Technical Service Bulletin

94 Headlight moisture accumulation

94 17 86 2030960/2 February 14, 2017. Supersedes Technical Service Bulletin Group 94 number 12-89 dated September 25, 2012 for reasons listed below.

Figure 3. Illustration of the ventilation components.

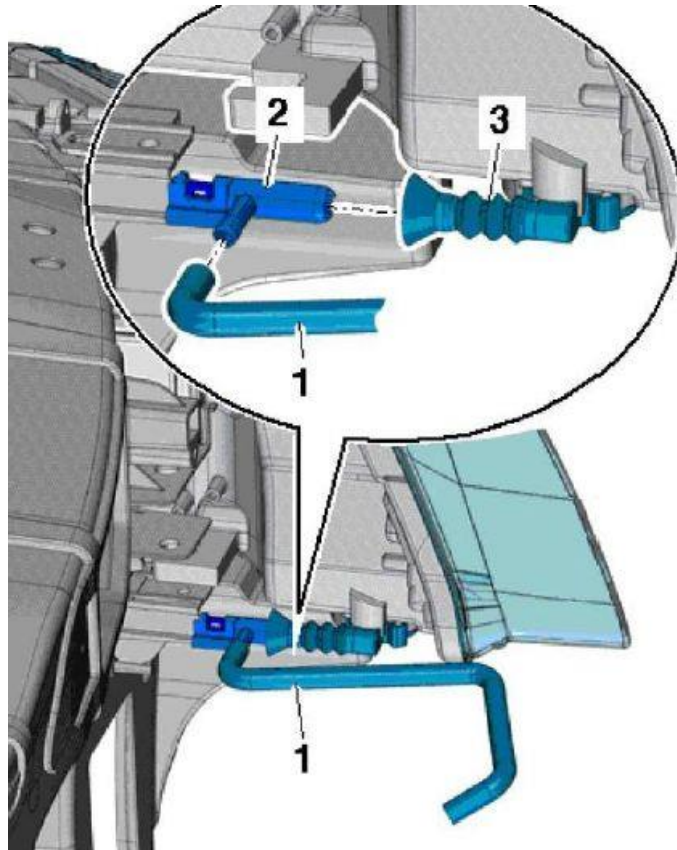
1. Remove and dry out the headlight(s) with compressed air (less than 30 PSI).
2. Replace the ventilation hose (Figure 3, 1) and adapter (Figure 3, 3) on both sides and attach it to the mounting (Figure 3, 2). Use the part numbers indicated in the Parts table below.

When replacing the headlight, follow the headlight condensation repair instructions above using a new ventilation hose (Figure 3, 1) and adapter (Figure 3, 3) according to the Parts table below. Route the new ventilation hose behind the bumper carrier.

Figure 4. Membrane from original adapter.

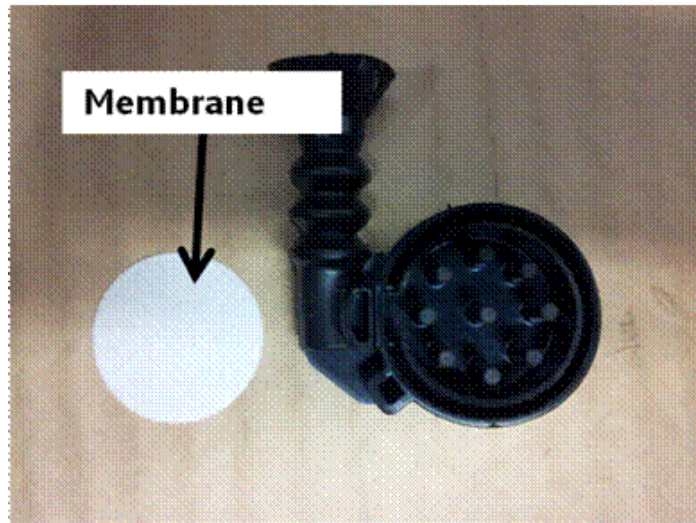
3. It is not necessary to use the membrane from the original adapter.

Figure 5. Illustration of the ventilation components.

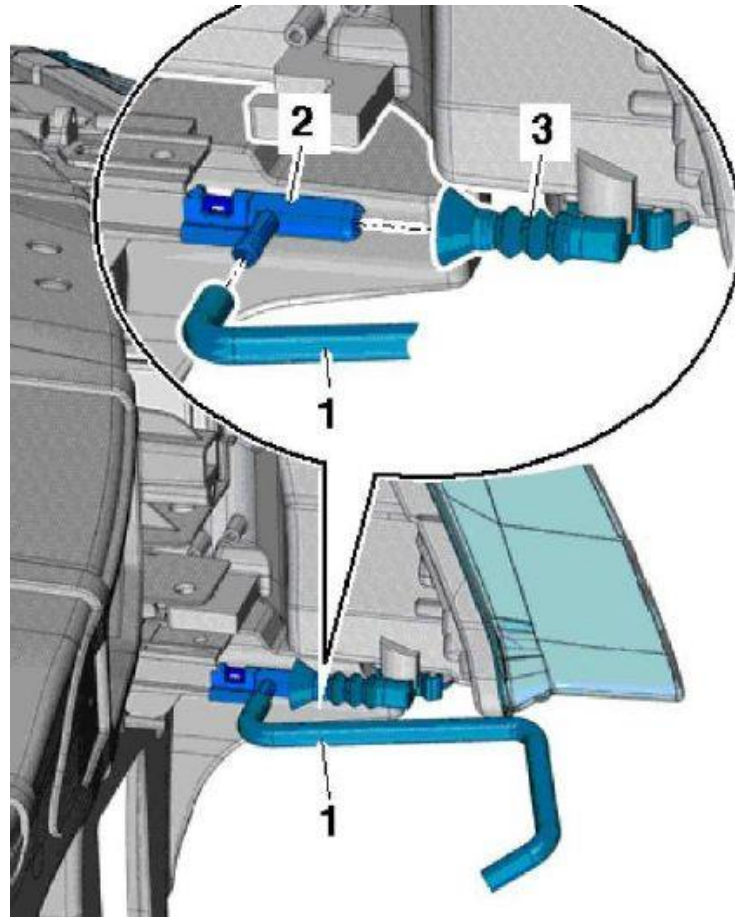
2. Replace the ventilation hose (Figure 5, 1) on both sides and attach it to the mounting (Figure 5, 2). Use the part numbers indicated in the Parts table below.
